# UNITED STATES PATENT AND TRADEMARK OFFICE

10/553,940

<b>Office Action Summary</b>	<b>Application No.</b> 10/553,940	<b>Applicant(s)</b> SONGER ET AL.	
	<b>Examiner</b> LYNNSY SCHNEIDER	<b>Art Unit</b> 4118

### **DETAILED ACTION**

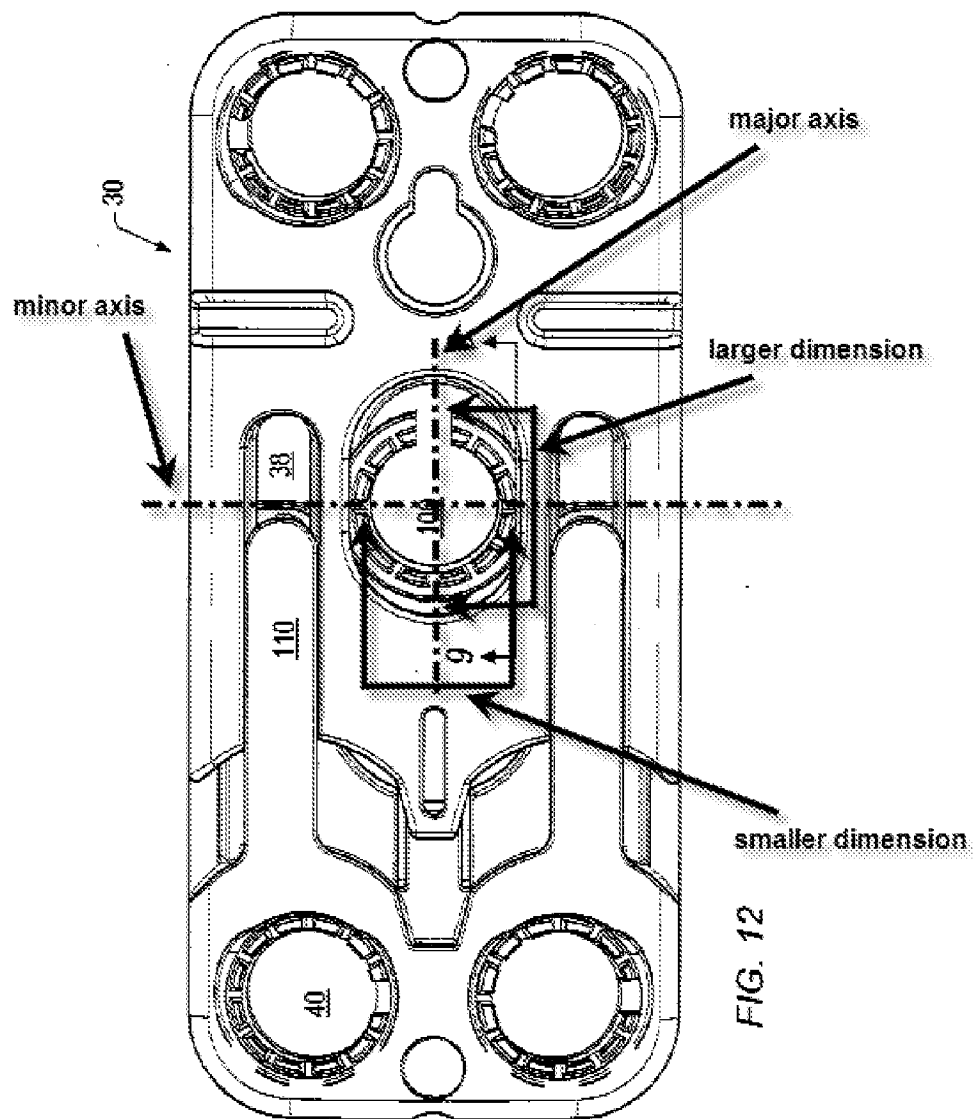
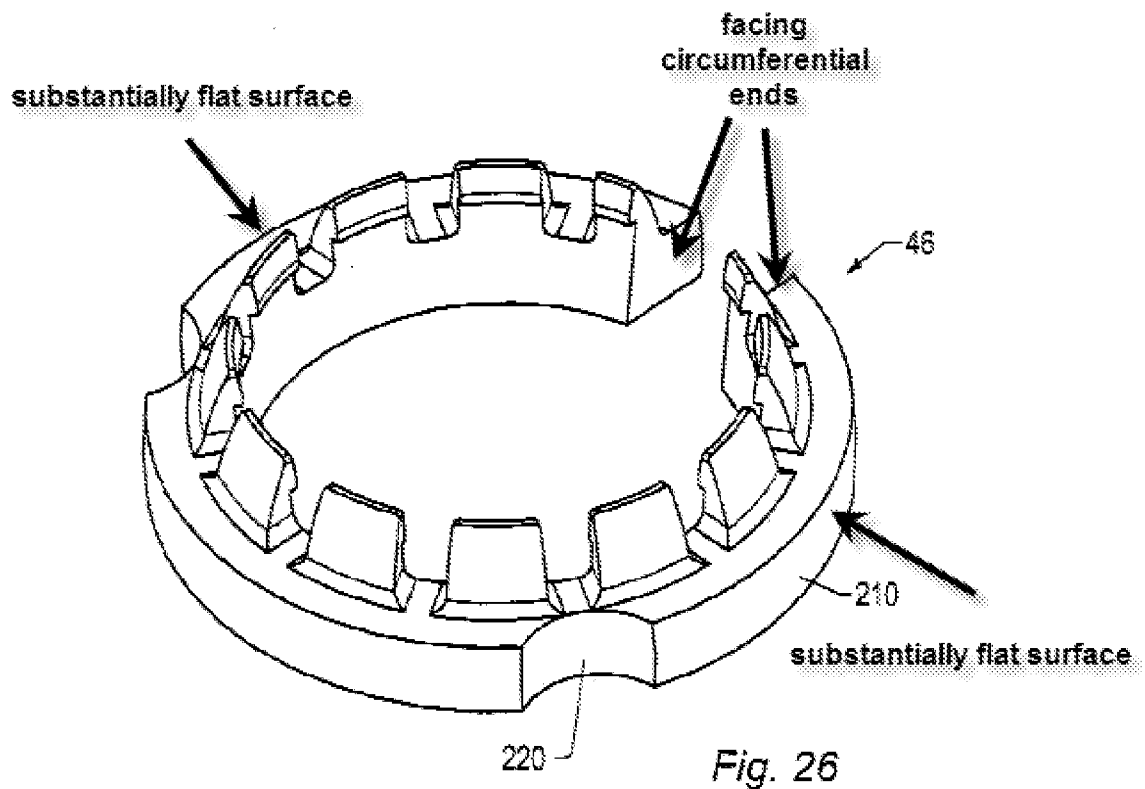
between a screw receiving unlocked configuration and a screw locking configuration; and a substantially smooth inner surface of the screw lock member 46 (figure 26) having an inner diameter sized in clearance with the bone screw 182 when in the screw receiving unlocked configuration (with projections 50 deflecting outward, paragraph 0073) with the inner diameter being substantially uniformly reduced in size when the screw lock member is in the screw locking configuration (with projections 50 contracted after insertion of the fastener, paragraph 0073) so that the smooth inner surface provides a uniform clamping force about the bone screw to allow relative translation thereof in the dynamized bore and keep the bone screw from backing out therefrom (paragraph 0073). The rotatable screw lock member 46 has a larger dimension (illustrated in figure 12) and a smaller dimension (illustrated in figure 12), the larger dimension being brought to bear against a recess 102 (figures 10 and 11, and paragraph 0096) located in the dynamized bore 100 upon rotation of the screw lock member from the screw receiving configuration to the screw locking configuration which shortens the larger dimension and causes the screw lock member to constrict about the bone screw (paragraph 0129). The dynamized bore recess 102 has both minor “second” and major “first” axes (figure 12 and paragraph 0095) and the larger dimension (illustrated in figure 26) of the screw lock member 46 is aligned with the major “first” axis of the recess when the screw lock member is in the screw receiving configuration and the minor “second” axis when the screw lock member is in the screw locking configuration (illustrated in figure 12). The substantially smooth inner surface of the screw lock member 46 conforms to a corresponding surface on the bone screw 182

(paragraph 0073), the screw lock member inner surface and the corresponding surface on the bone screw 182 having a greater coefficient of friction than the larger dimension 210 of the rotatable screw lock member 46 and the dynamized bore recess 102 to permit dynamization of the rotatable screw lock member within the bore without loosening engagement of the screw lock member about the bone screw (paragraph 0074). In paragraph 0074, Fried et al. discloses that the retainer 46 may engage a head of a fastener without the retainer binding to the plate. Since the inner surface of the retainer is engaging the head of a fastener and the retainer is still moveable in the plate, the coefficient of friction between the recess 102 and the outer surface 210 of the retainer is less than between the outer surface of the fastener head and the inner surface of the retainer.
